<b>MEETING:</b>	<b>PLANNING AND REGULATORY COMMITTEE</b>
<b>DATE:</b>	<b>17 JANUARY 2024</b>
<b>TITLE OF REPORT:</b>	<p><b>163932 - OUTLINE PLANNING APPLICATION FOR A SUSTAINABLE URBAN EXTENSION COMPRISING: UP-TO 250 DWELLINGS; OPEN SPACE, ALLOTMENTS AND LANDSCAPING; SCHOOL EXPANSION LAND; AREAS OF CHILDREN'S PLAY; SUSTAINABLE URBAN DRAINAGE INFRASTRUCTURE; INTERNAL ROADS; AND ASSOCIATED INFRASTRUCTURE. DETAILED APPROVAL IS SOUGHT FOR PRINCIPAL MEANS OF ACCESS AND LAYOUT WITH ALL OTHER MATTERS RESERVED AT LAND AT HARDWICK BANK, BROMYARD, HEREFORDSHIRE,</b></p> <p><b>For: Vistry Homes Limited and Mosiac Estates per Russell Smith, McLoughlin Planning, 119 Promenade, Cheltenham, GL50 1NW</b></p>
<b>WEBSITE LINK:</b>	<a href="https://www.herefordshire.gov.uk/info/200142/planning_services/planning_application_search/details?id=163932&amp;search-term=163932">https://www.herefordshire.gov.uk/info/200142/planning_services/planning_application_search/details?id=163932&amp;search-term=163932</a>

**Figure 1 – Composite Site Plan**

### *Internal Layout*

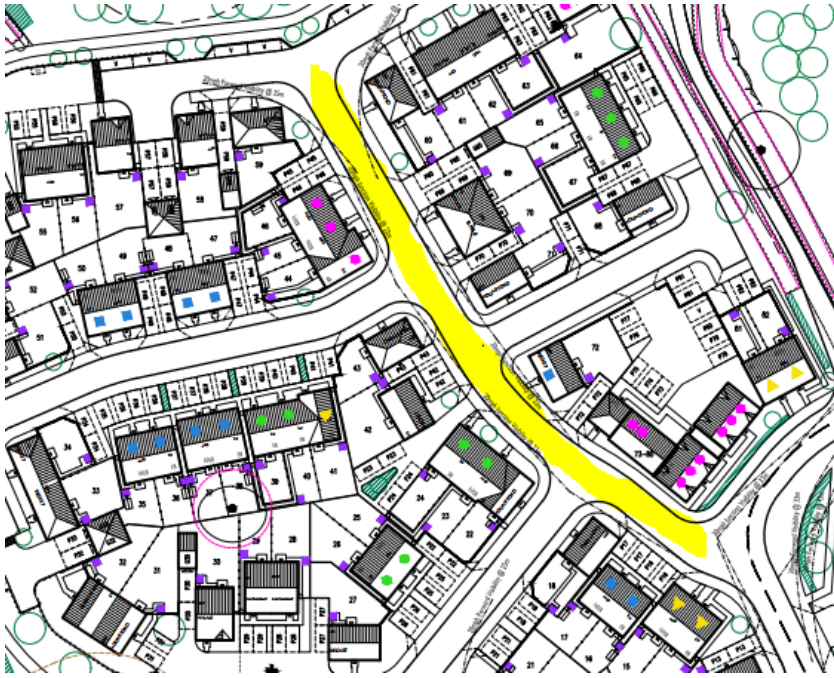
The internal layout is a matter for consider in this application as it is not a reserved matter. The site is based around a central spine road which is 6m in width with a 3m shared footway/cycleway along the southern/eastern side and a 2m footway on the opposite side. Further residential streets are accessed off the spine road.

A number of issues with the layout still remain despite being raised on a number of occasions with the applicant. These are addressed in more detail below but if planning approval is granted the issues will need to be rectified via conditions.

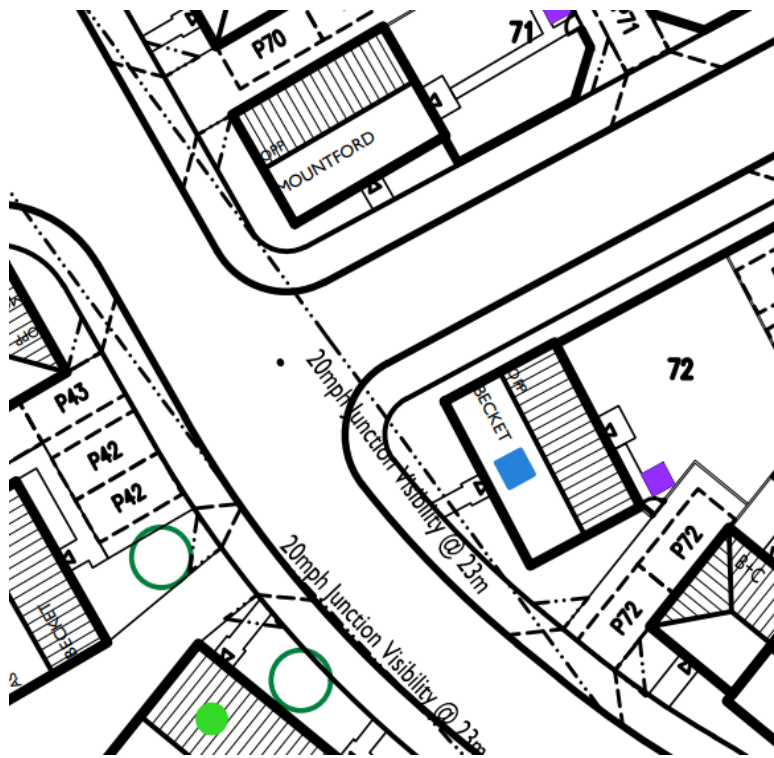
The LHA require visibility splays of 2.4m x 33m to be provided at all junctions along the spine road through the site, this is commensurate with speeds of 25mph. The applicant has agreed that these are appropriate, however, the visibility splays demonstrated on the plans provided are incorrectly drawn. For example, below is a screenshot of one of the visibility splays. As can be seen the x distance does not appear to be 2.4m (for context the footway/cycleway at the junction is 3m wide and the visibility splay x distance should be setback 2.4m from the give-way line). The x distance appears to sit on the give-way line rather than being setback 2.4m.

Our Highway Design Guide for New Developments states that for roads which serve between 25 and 100 dwellings (the above example serves 66 dwellings) should be 5.5m in width, as the above example is, and have visibility splays of 33m. Therefore visibility splays of 2.4m x 33m have been requested on a number of occasions, however, the applicant has been unwilling to provide them.

Another issue in regards to the provision of visibility splays is that the back of the footway should follow the visibility splay line to ensure that it does not encroach on third party land such as someone's front garden whereby planting may block the visibility splay. This again has been raised as an issue several times but still has not been rectified, as demonstrated in the screenshot below which shows even a 23m splay crossing a front garden, if this was lengthened to the required 33m splay then it is likely that the splay would cross the parking space for plot 72 and be blocked by a parked car on private land. The below example may even require the house to be positioned further back in order to avoid blocking the visibility splay. This could potentially require an application for a non-material amendment should planning be granted.

1. A plan demonstrating visibility splays of 2.4m x 33m with the splay being delineated by the back of the footway at all junctions should be provided prior to commencement on site for the approval by the LHA/LPA. Nothing over 0.6m in height should be placed within the splays. This condition overrides the visibility splays demonstrated on drawing 0687-102.
